# Access Compliance Report

## Public Rights-of-Way

### (Curb Ramps)

Intersection ID: 42757	Main Street: ELAM_CT	Cross Street: LEES_CROSSING_DR	Location: W
ADA ID: 6F782192A124	Ramp Type: PerpDiag	Initial Pass/Fail: Fail	Overall Compliance: No
Severity Score: 46.25			
Codes/Mitigation Info/Possible Solution		Field Measurements/Component Compliance

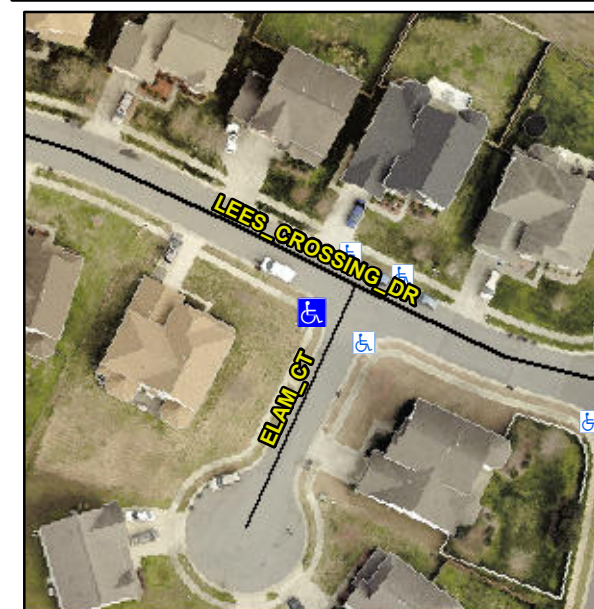
**Not Found, R304.5.1, R304.2.2, R304.5.3**

Compliance	Description	Data	Compliance	Description	Data
N/A	Ramp Length (in)	44.0	No	Ramp Slope (%)	10.8
No	Ramp Width (in)	36.0	No	Ramp XSlope (%)	7.9
N/A	Flare Type LT	N/A	N/A	Flare Type RT	N/A
N/A	Flare Slope LT (%)	N/A	N/A	Flare Slope RT (%)	N/A
N/A	Flare Traversable LT?	N/A	N/A	Flare Traversable RT?	N/A
N/A	Landing Length (in)	N/A	N/A	DWS Provided?	N/A
N/A	Landing Width (in)	N/A	N/A	DWS Contrast?	N/A
N/A	Landing Slope (%)	N/A	N/A	DWS Length (in)	N/A
N/A	Landing X Slope (%)	N/A	N/A	DWS Full Width?	N/A
N/A	Landing Curb? (Y/N)	N/A	N/A	DWS Offset (in)	N/A
N/A	Shared Landing?	N/A			
N/A	Gutter Ponding?	N/A	N/A	Gutter Slope (%)	N/A
N/A	Gutter Lip Ht (in)	N/A	N/A	Gutter X Slope (%)	N/A
N/A	Painted X Walk1?	No	N/A	Painted X Walk2?	No
	X Walk 1 Direction	To SE		X Walk 2 Direction	To NE
N/A	X Walk 1 Width (in)	N/A	N/A	X Walk 2 Width (in)	N/A
	X Walk 1 Slope (%)	6.0		X Walk 2 Slope (%)	2.9
	X Walk 1 X Slope (%)	3.0		X Walk 2 X Slope (%)	7.4

**Remove & Replace Curb Ramp With Two New Directional Ramps or Equivalent.**
